In addition to the comments we recently provided regarding certain aspects of the environmental study process under the National Environmental Policy Act (NEPA), we offer the following comments that specifically relate to the Section 106 Historic Properties Identification Report (Section 106 Report). While we don't reiterate the NEPA process points here, it is important to recognize that our Section 106 comments nevertheless hinge upon the critical disconnect between the unduly narrow purpose and need statement for the project, and the unstated fact that all proposed roadwork, rather than just road improvements resulting from road closures, is to accommodate the Obama Presidential Center. In this sense, we note that many of the arguments regarding impacts set forth herein are causally related to, and would not occur but for the Obama Presidential Center project. This holds true for every comment below, with the exception of the first comment pertaining to the project's Area of Potential Effect. Therefore, we respectfully submit the following comments with this context in mind.

I. The Area of Potential Effect (APE) Excludes Neighborhoods that Would Be Impacted by the Obama Presiden

Figure 1: Diagram Supporting Revised APE

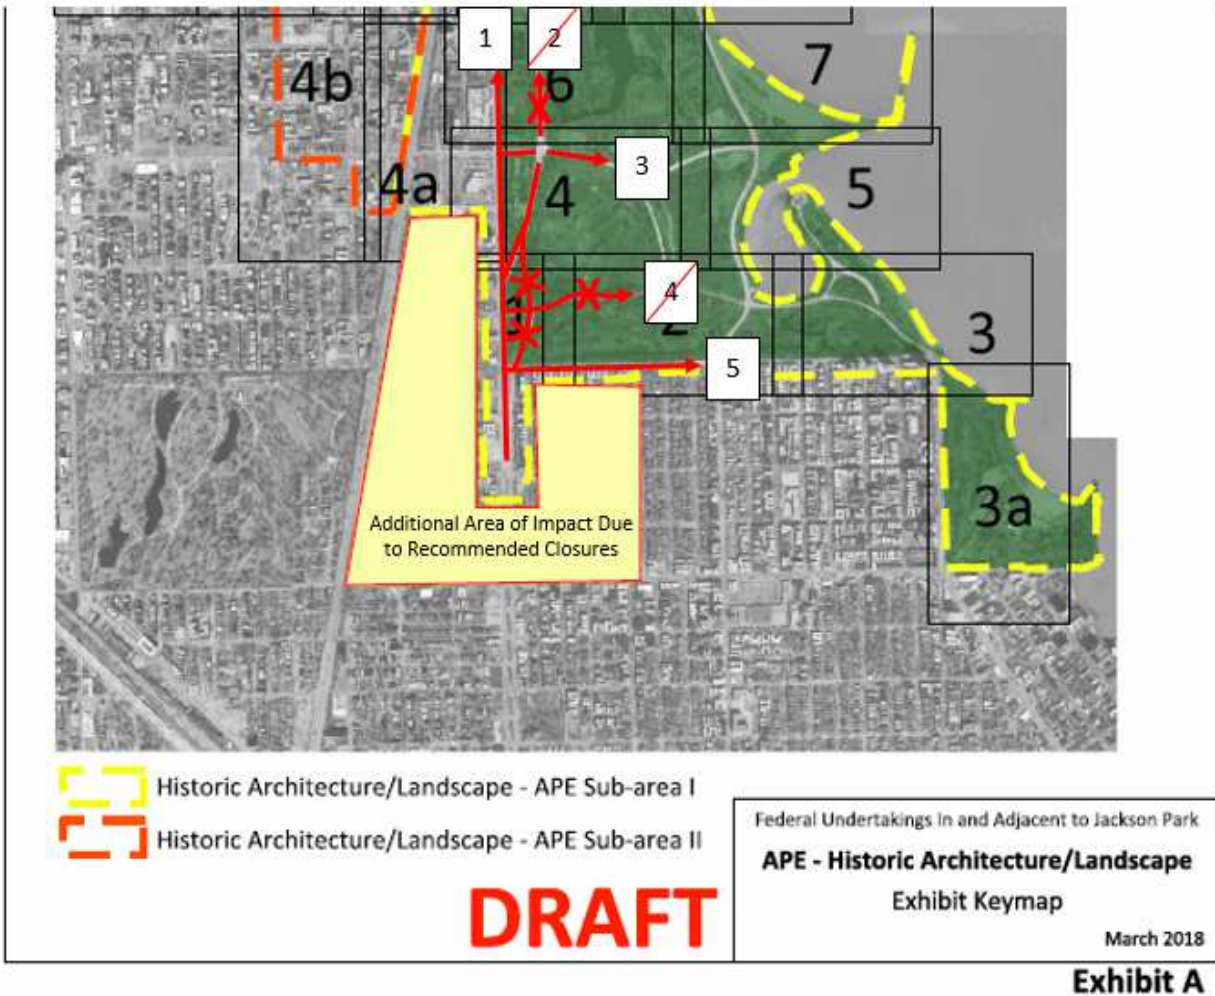
The Section 106 Report states that requests were “made for modifications to the Historic Architecture/Landscape APE. These requests were considered and evaluated based on three criteria: consideration of the development history that could be linked to Jackson Park, the likelihood of direct impacts as a result of potential construction, and the likelihood of indirect visual impact as a result of the construction of the OPC Tower,” Section 106 Report, p. ii. Yet, the Historic Properties Identification Report prepared for FHWA and the National Park Service rejected designating Jackson Park Highlands and/or the South Shore Neighborhood as part of the APE. While we agree that the APE does not need to include the full area of both neighborhoods, with the acknowledged impacts, the APE should extend to portions of these neighborhoods. Simply, the range of road alternatives carrying traffic into and out of portions of South Shore are reduced from five to three, due to the proposed closures. Given that the proposed closures, ensuing circulation patterns, and traffic issues will almost certainly impact these neighborhoods, the decision to exclude at least the portion of South Shore as indicated from the APE seems illogical given criteria two highlighted above. Therefore, at the very least, we recommend that the portion of South Shore bounded north to south between 67th and 71st Streets and east to west between Cregier Avenue and Stony Island be included as indicated by the diagram below, as these meet the criteria in the Section 106 Report.

Figure 5: Chicago Park District Diagram of Proposed Road Closures at Western Periphery of Jackson Park

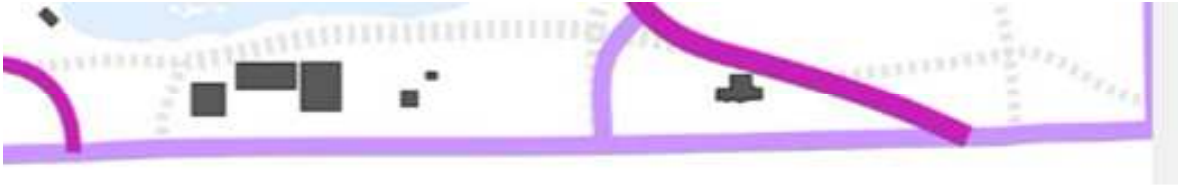
Furthermore, the Section 106 report states that “[t]he southbound lanes of S. Cornell Drive were rerouted across the southwest corner of the park. Other roadways were moderately widened, but generally following their historic alignments. As a result of these projects, the landscape of the Western Perimeter was substantially altered.” This contradiction results in acknowledging and protecting certain Section 106 resources while not protecting other historic features that have the same critical import. There are other examples of this omission. The Section 106 Report proposes the closure of the historic route of Cornell Drive at the southwestern corner of the park, while allowing the spur between Cornell and Stony Island, identified as an impact, to remain. A comparison of Figures 14 and 15 illustrate this contradiction, when juxtaposed to the proposed closures.
